SERVICE BULLETIN

N° **189-381**

ATA 11 – ADDITIONAL MARKINGS FOR CS26 AMDT 4 KIT INSTALLATION

This SB is applicable to all AW189 helicopters operating under EASA authority that make over water operations in accordance with point CAT.IDE.H.320(a) of Annex IV to Regulation (EU) No 965/2012.

Figure 20

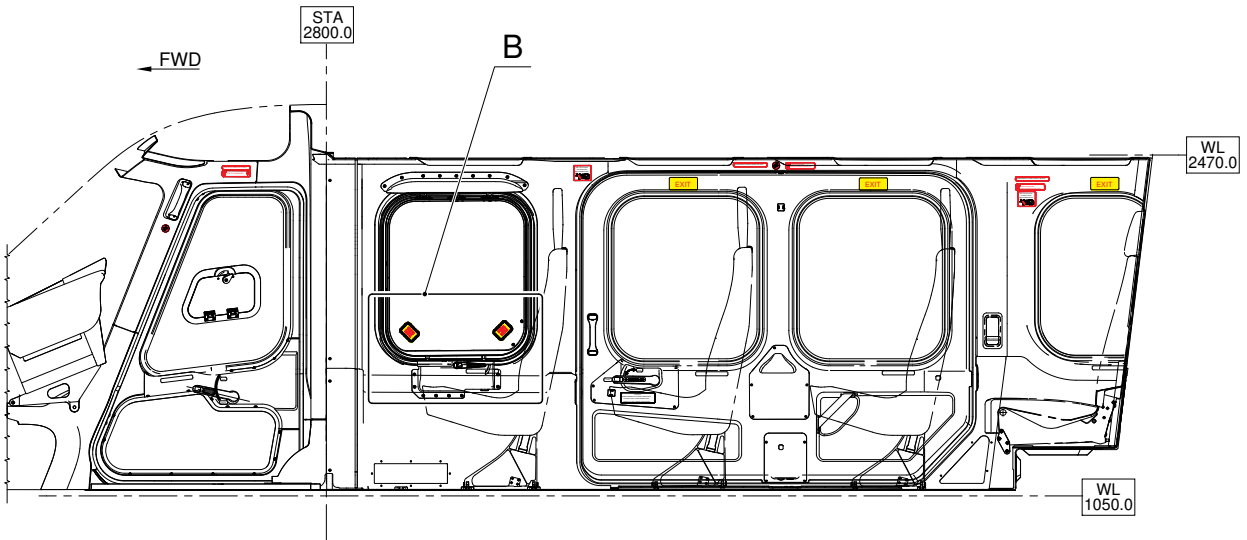
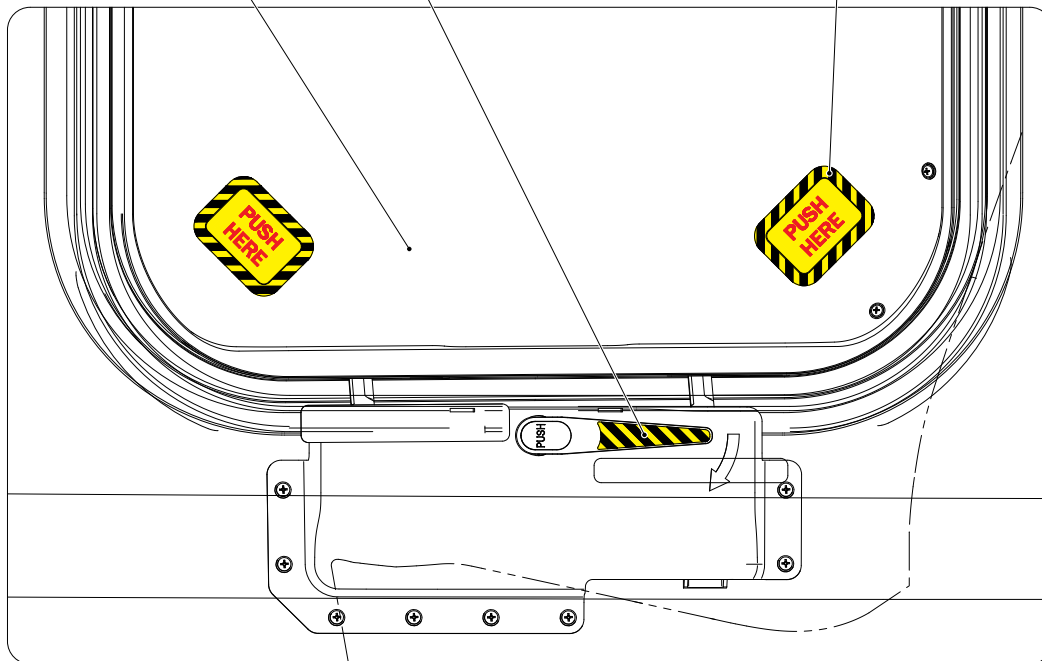
19. In accordance with AMP DM 89-A-11-00-01-00A-720A-A and with reference to Figure 20 Detail B, install n°2 decals P/N 3G1130A27153 on the LH or RH forward cabin window.
20. In accordance with AMP DM 89-A-11-00-01-00A-720A-A and with reference to Figure 20 Detail B, install the decal P/N 8G1100A00851 on the release handle of the LH or RH forward cabin window.

20. In accordance with AMP DM 89-A-11-00-01-00A-720A-A and with reference to Figure 20 Detail B, install n°2 decals P/N 3G1130A27153 on the LH or RH forward cabin window.
21. In accordance with AMP DM 89-A-11-00-01-00A-720A-A and with reference to Figure 20 Detail B, install the decal P/N 8G1100A00851 on the release handle of the LH or RH forward cabin window.

Figure 21

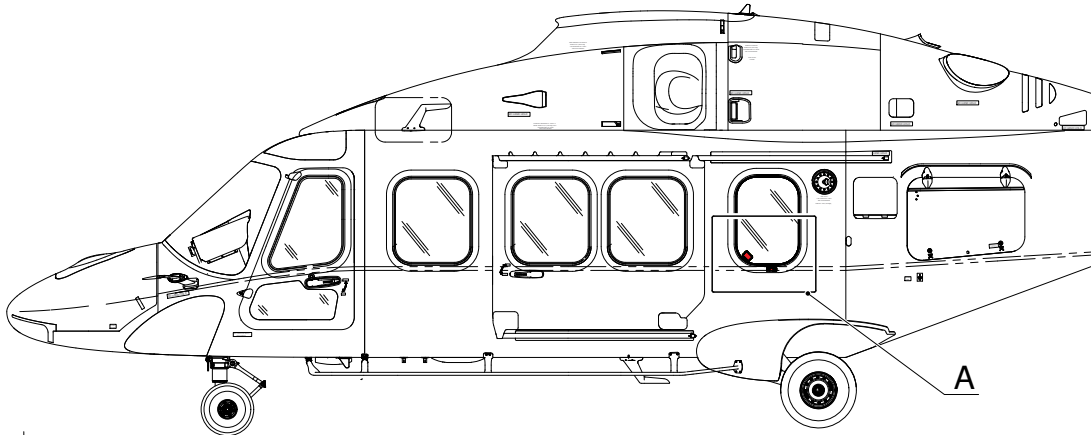
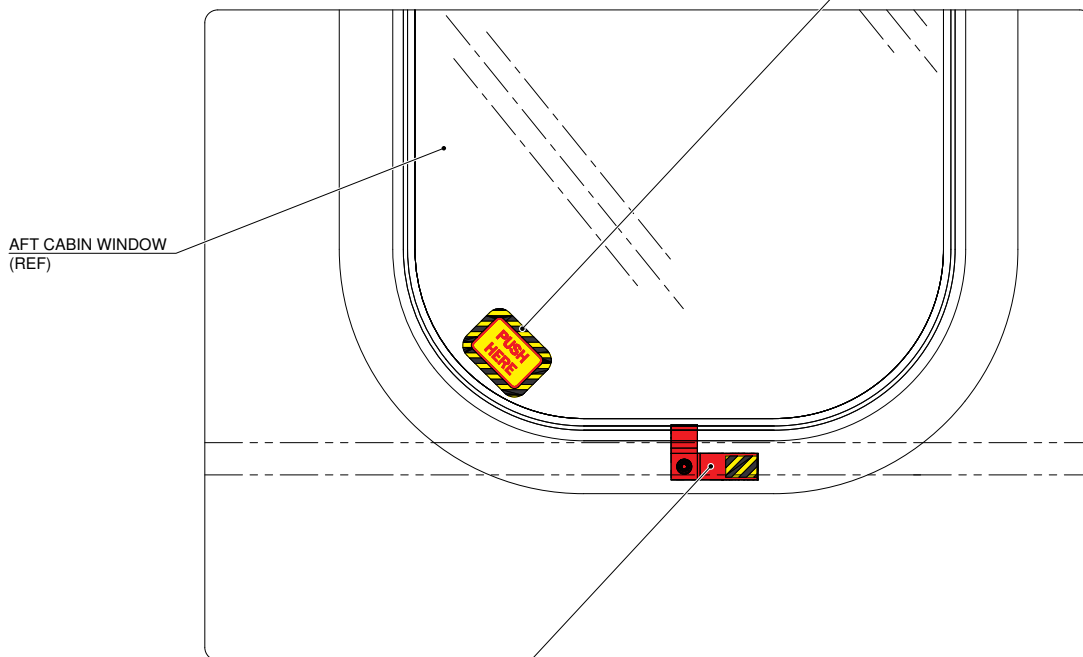
12. With reference to Figure 21 Detail A and Figure 29, sew the “decal CS26 pull strap” P/N 3G1130A27152
13. by means of synthetic commercial yarn (colour red, n°31136 per FED-STD-595) on the strap assembly P/N A487A005A.

14. In accordance with the applicable steps of AMP DM 89-A-56-21-03-00A-920A-A or 89-A-56-21-04-00A-920A-A and with reference to Figure 21 Detail A, from the LH or RH aft cabin window, remove the strap assembly P/N A487A005A or any other different basic version.
15. In accordance with the applicable steps of AMP DM 89-A-56-21-03-00A-920A-A or 89-A-56-21-04-00A-920A-A and with reference to Figure 21 Detail A, install the “pull strap CS26 side wall” P/N 3G5211A14432 on the LH or RH aft cabin window.

16. In accordance with AMP DM 89-A-11-00-01-00A-720A-A and with reference to Figure 21 Detail A, install the decal P/N 3G1130A27153 on the LH or RH aft cabin window.

15. In accordance with the applicable steps of AMP DM 89-A-56-21-03-00A-920A-A or 89-A-56-21-04-00A-920A-A and with reference to Figure 21 Detail A, from the LH or RH aft cabin window, remove the strap assembly P/N A487A005A or any other different basic version.
16. In accordance with the applicable steps of AMP DM 89-A-56-21-03-00A-920A-A or 89-A-56-21-04-00A-920A-A and with reference to Figure 21 Detail A, install the “pull strap CS26 side wall” P/N 3G5211A14432 on the LH or RH aft cabin window.

17. In accordance with AMP DM 89-A-11-00-01-00A-720A-A and with reference to Figure 21 Detail A, install the decal P/N 3G1130A27153 on the LH or RH aft cabin window.

17. In accordance with AMP DM 89-A-11-00-01-00A-720A-A and with reference to Figure 21 Detail A, install the decal P/N 3G1130A27153 on the LH or RH aft cabin window.

Figure 29

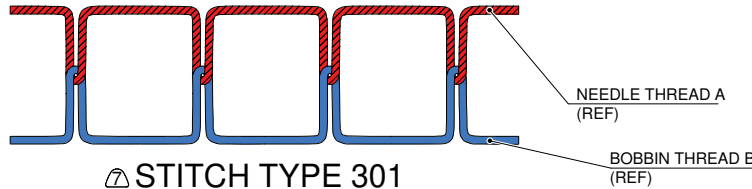
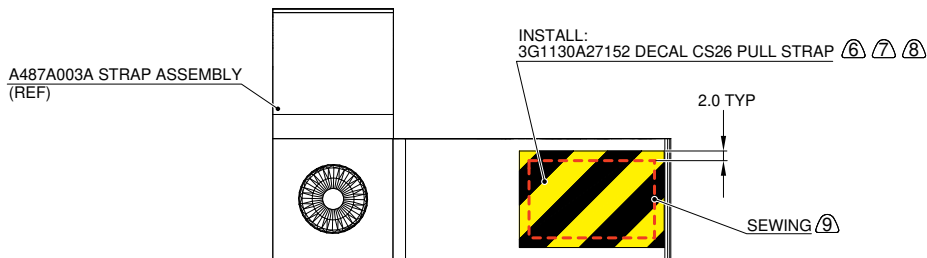
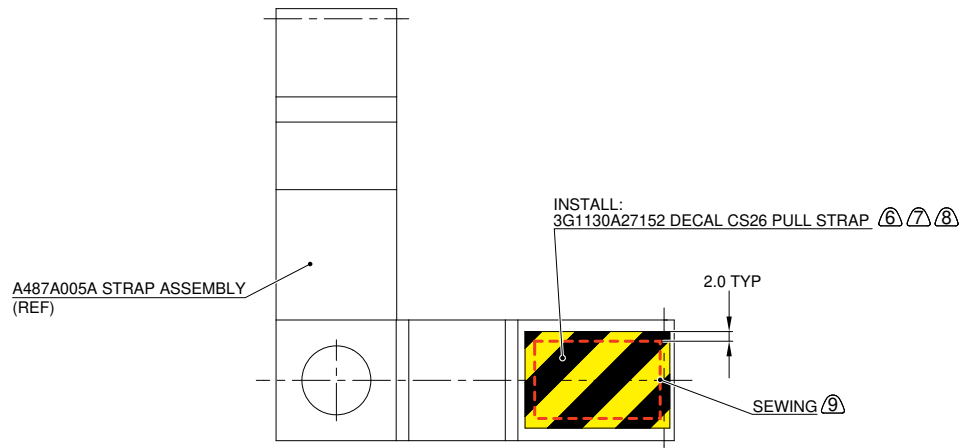
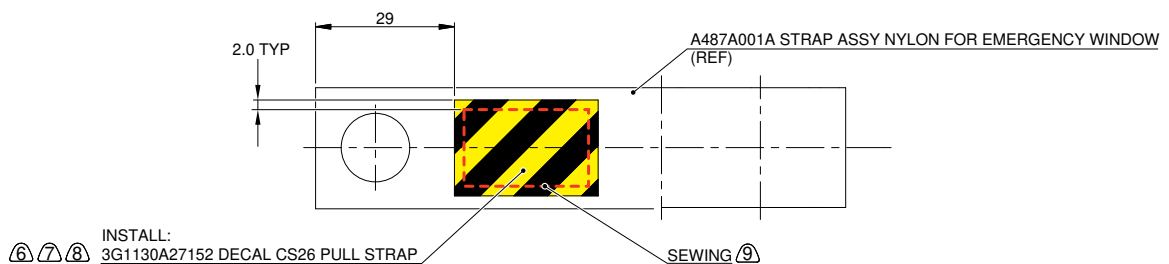
All sewing must be done in accordance with the specification ASTM D6193 type 301, from 6 to 8 stitches every 25 mm (Ref. Figure 29).

All sewing must be done in accordance with the specification ASTM D6193 type 301, from 6 to 8 stitches every 25 mm (Ref. Figure 29).

All sewing must be done in accordance with the specification ASTM D6193 type 301, from 6 to 8 stitches every 25 mm (Ref. Figure 29).
